Local Traffic Committee Meeting

Venue	Conference Room, Station Street, Mullumbimby
Date	Tuesday, 3 June 2025
Time	9:00 AM

Report No. 6.1 Intersection upgrade at 189 Federal Drive

PLAN
SCALE 1:200

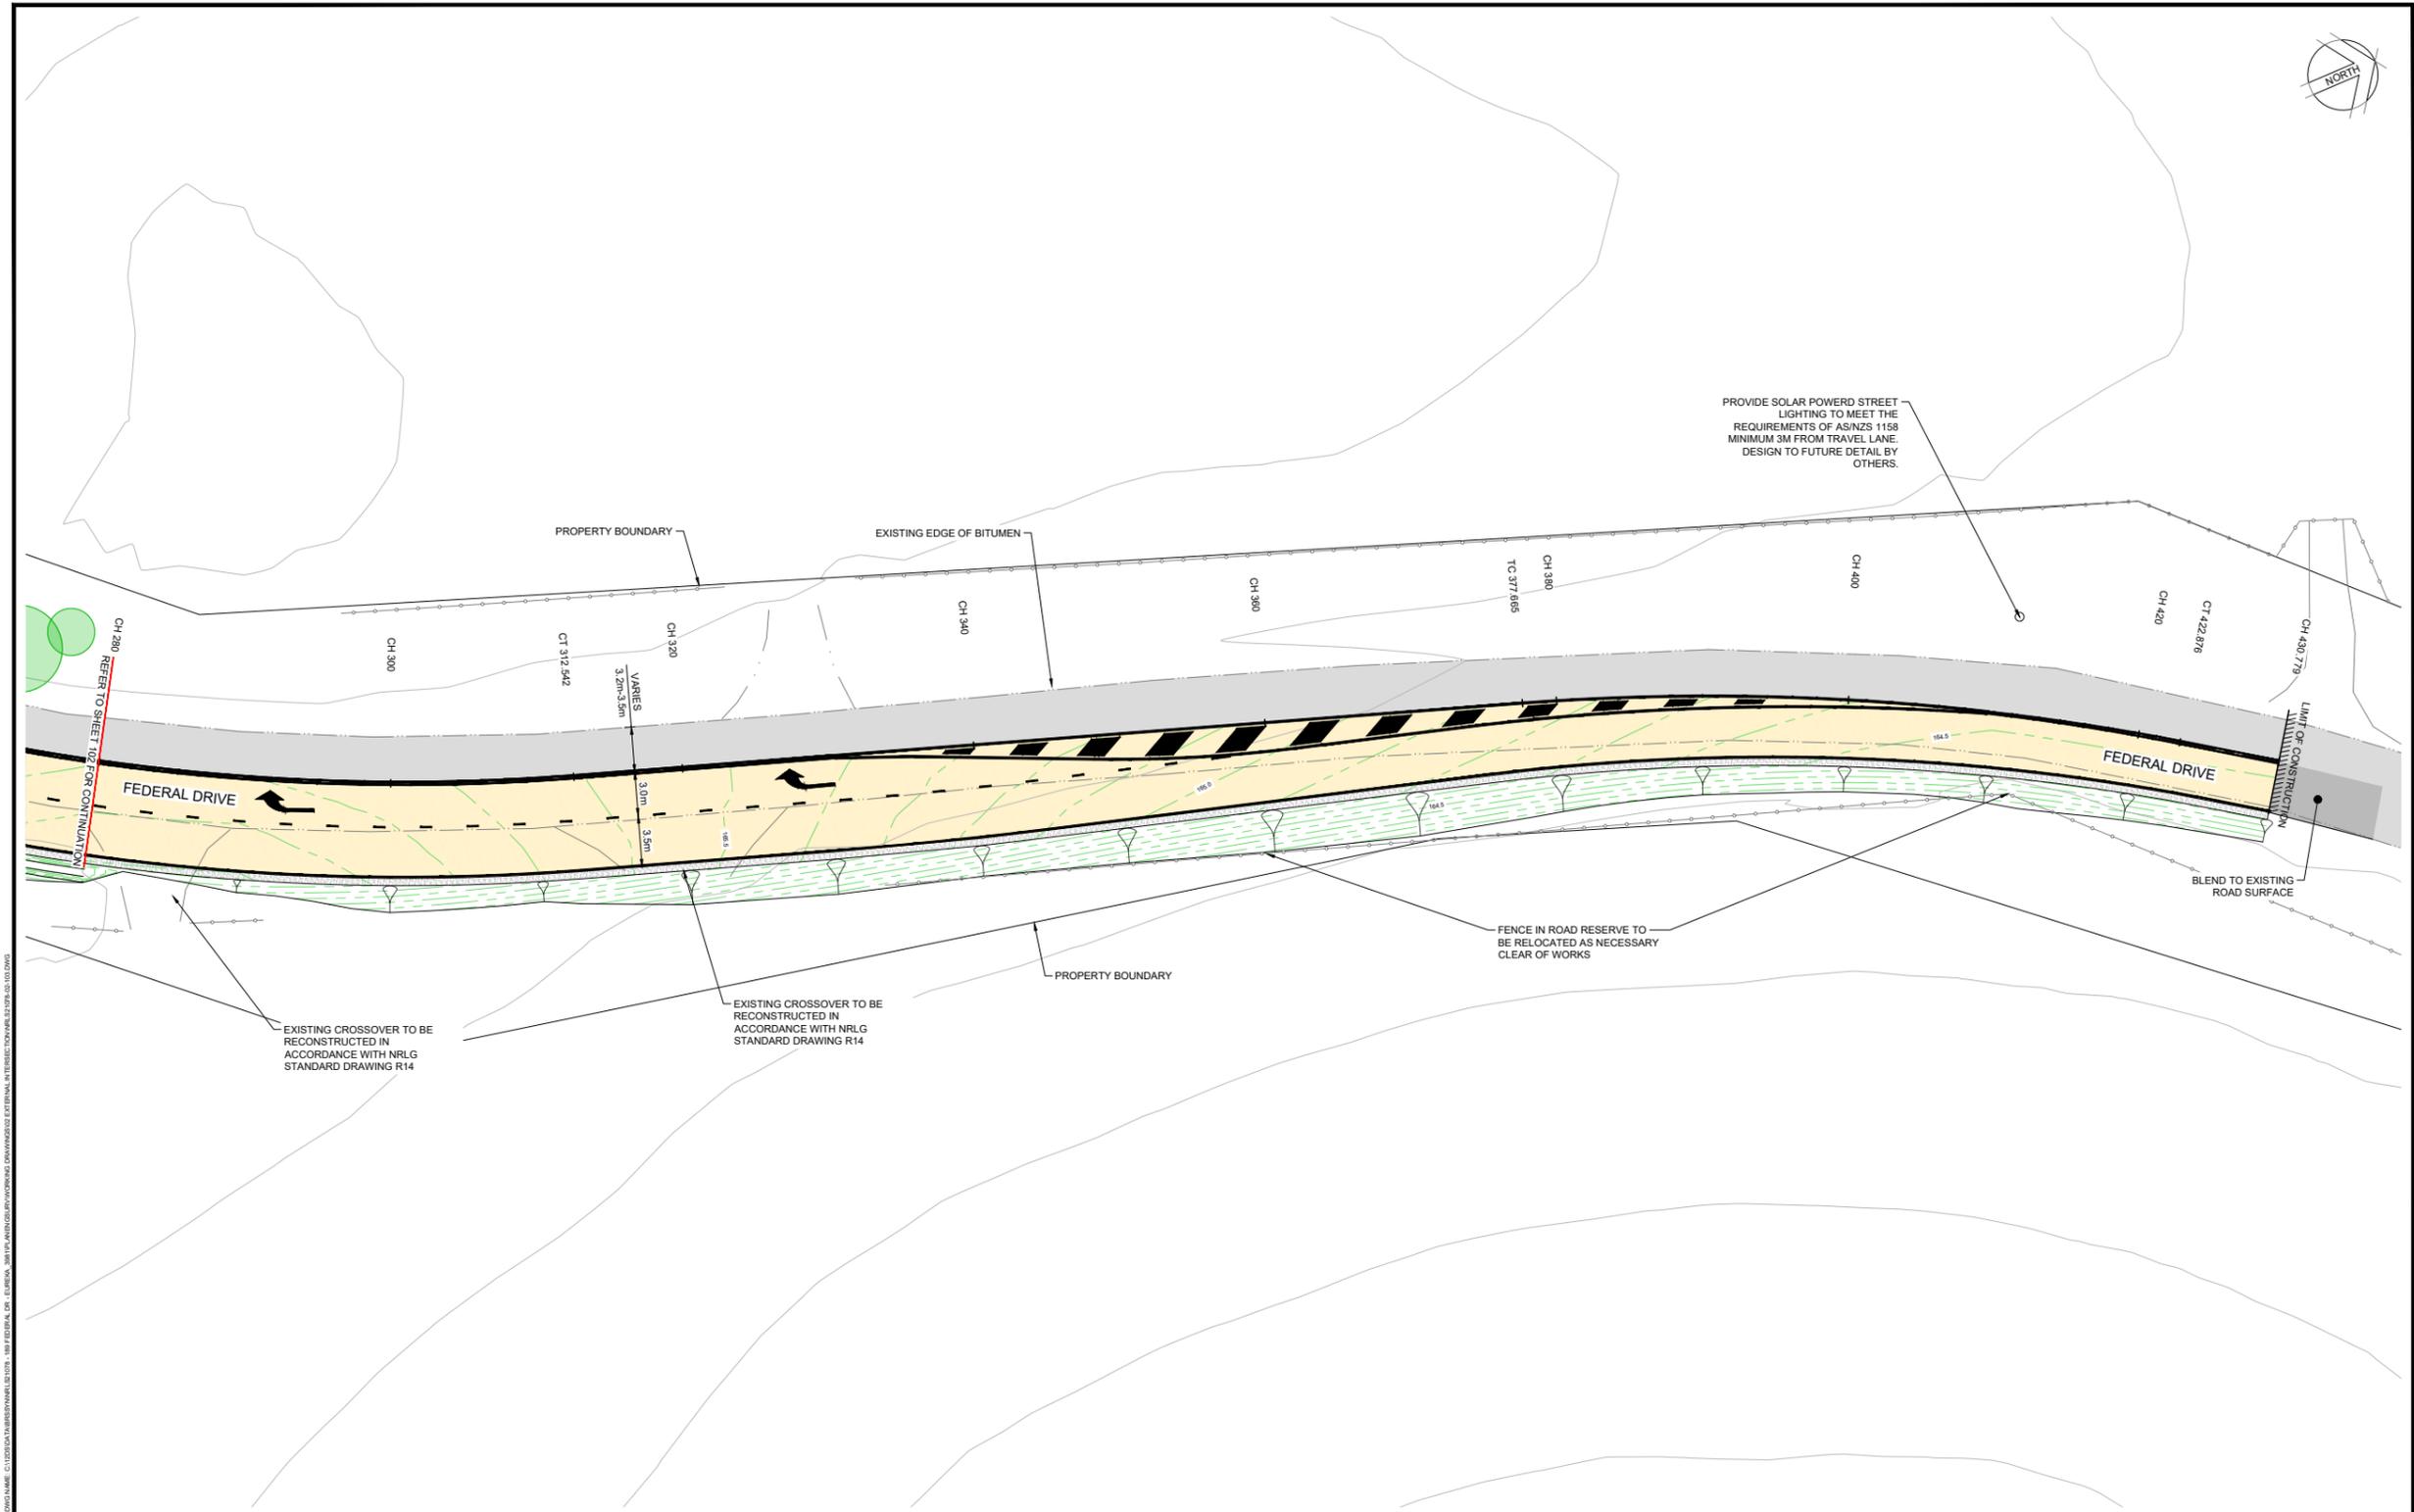
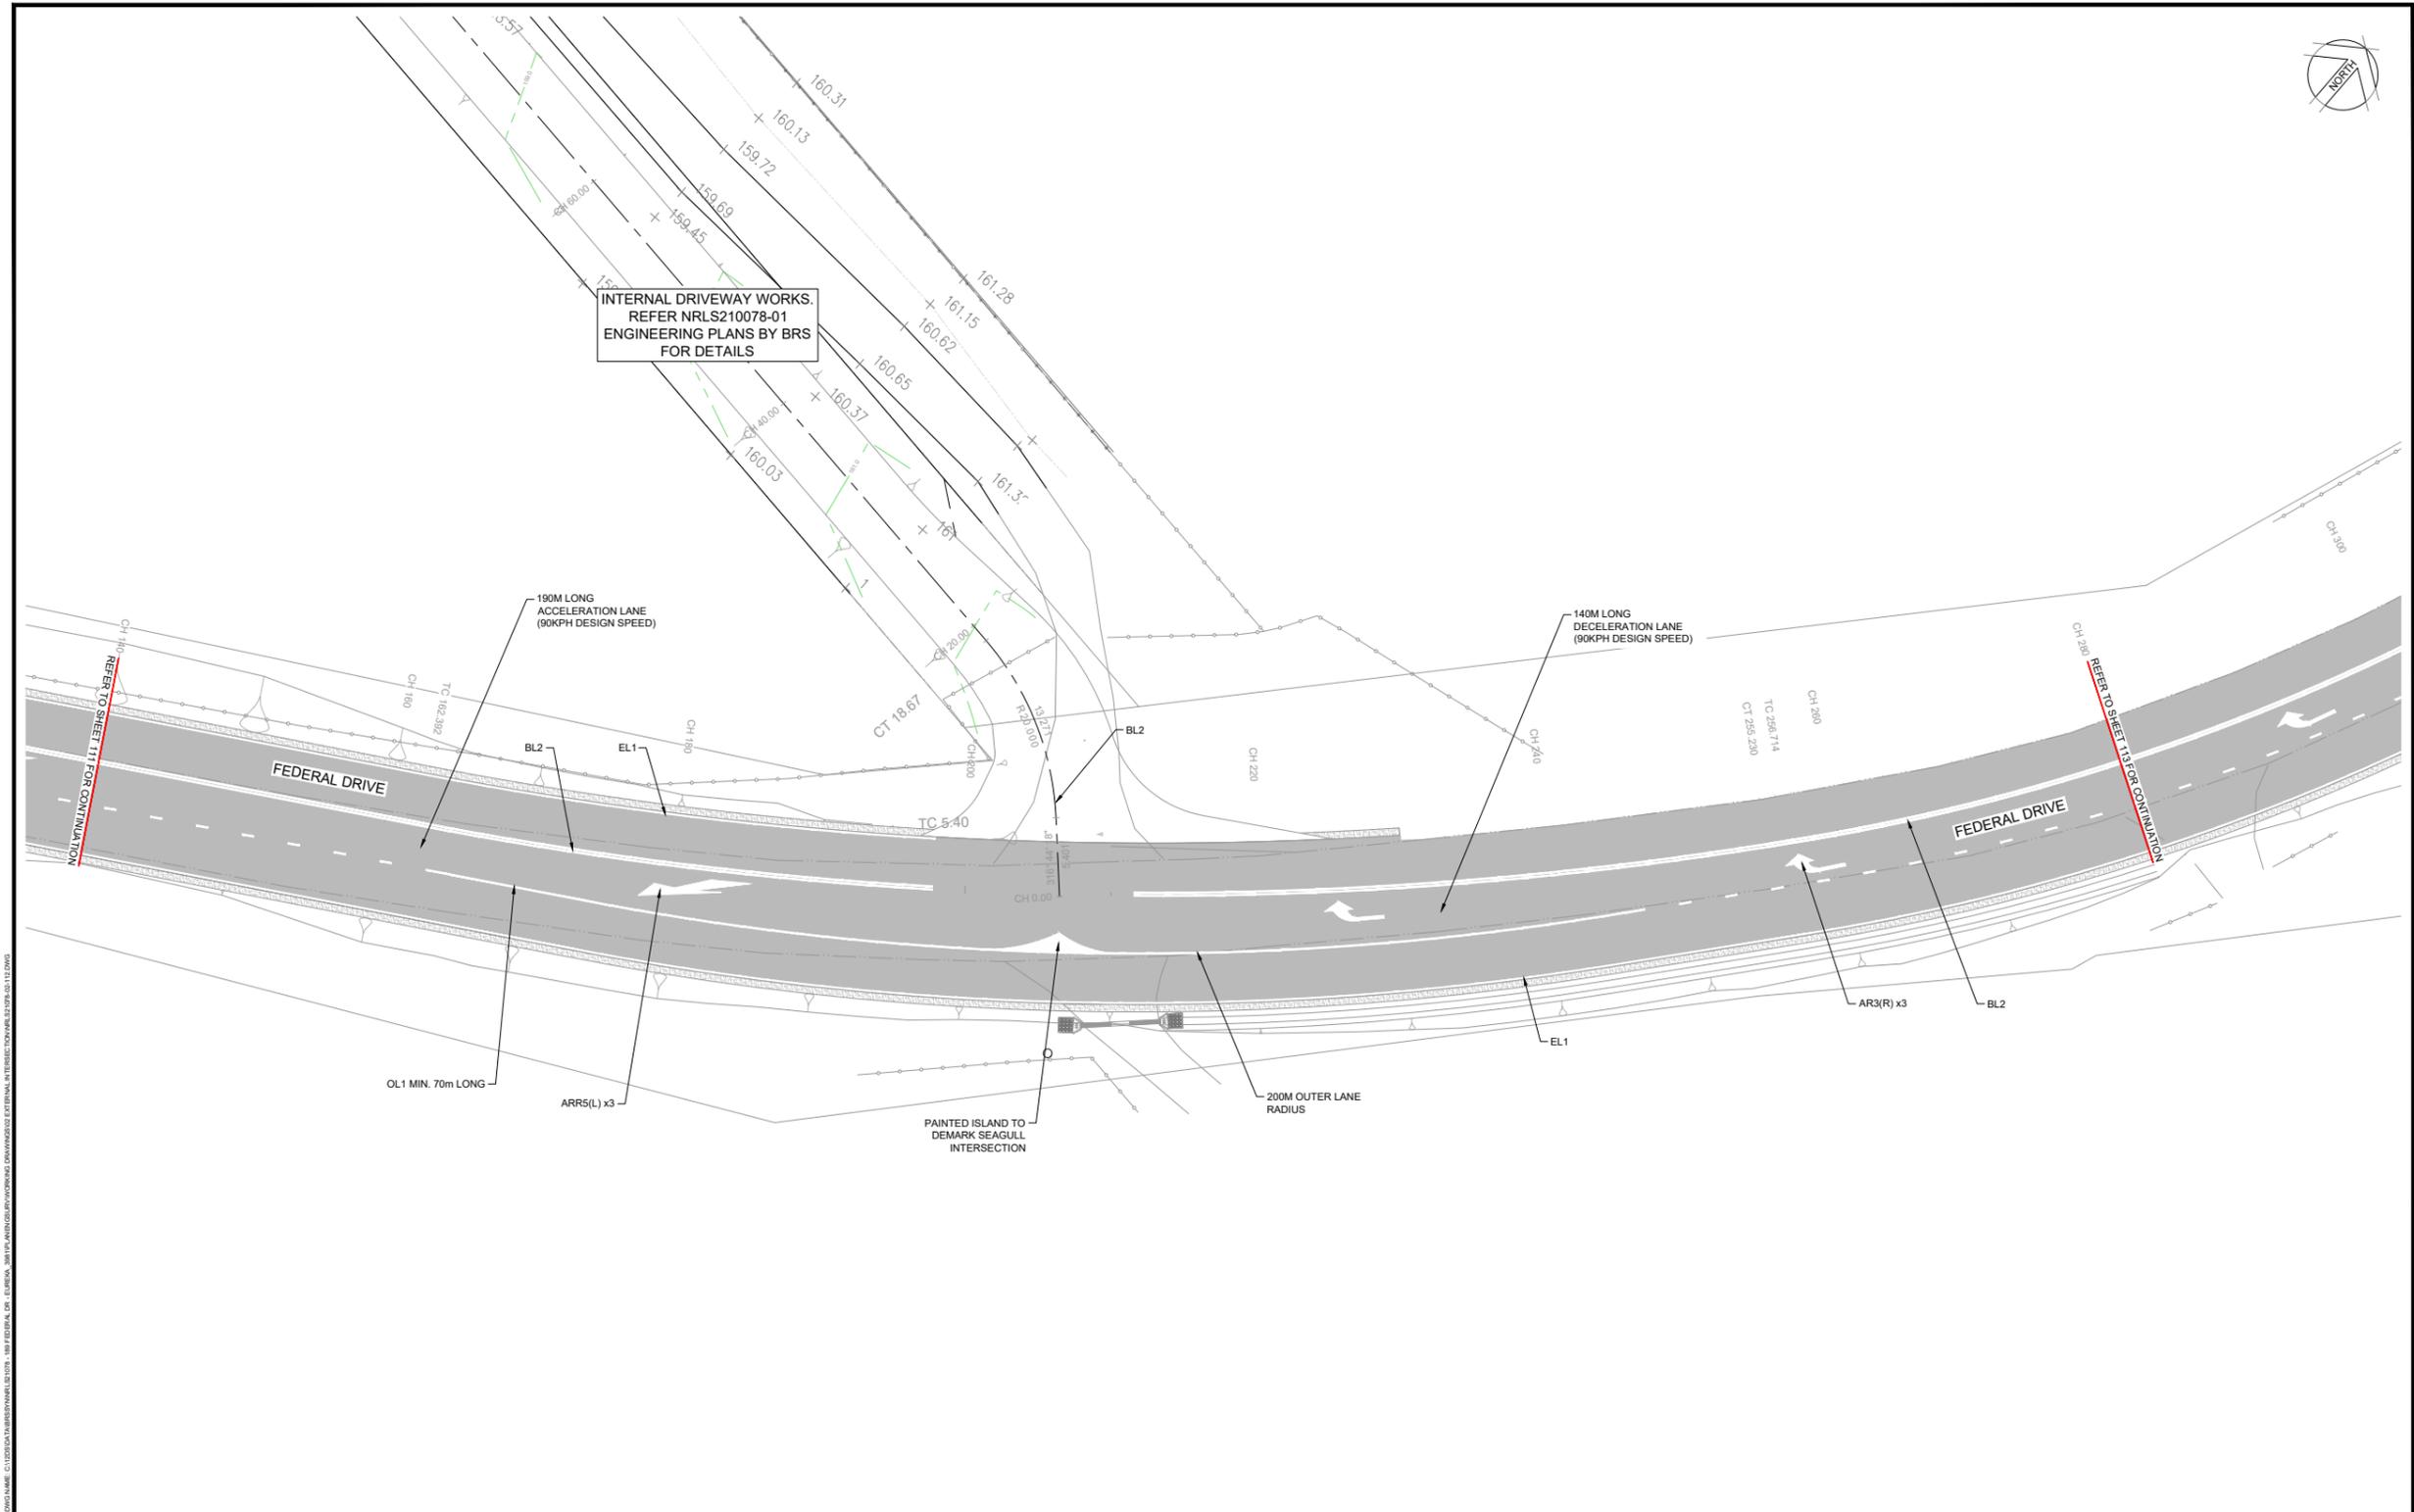
The following changes and requirements must be adopted into the modified seagull intersection design:

- Travel lane at 3.5m.
- Auxiliary lane at 3.0m
- Length of seagull painted island at 70m
- Width of seagull painted island at 3.5m
- Flag lighting in accordance with AS1158
- Acceleration lanes, deceleration lanes, painted medians, right turns, left turns but not limited to in accordance with Austroads Guide to Road Design
- Design speed of 90kph
- The seagull treatment must be supported with a swept path analysis plan to cater for a standard side loading refuse collection vehicle (RCV) specified in Chapter B8 of Council's BDCP coming from all directions. The RCV must enter and exit in forward direction.

Note: the supporting swept path analysis plan did not include maneuvering coming from the north and exiting heading south

That the Local Traffic Committee endorses the proposed intersection plan as nominated in Attachment 1 (E2025/51169).
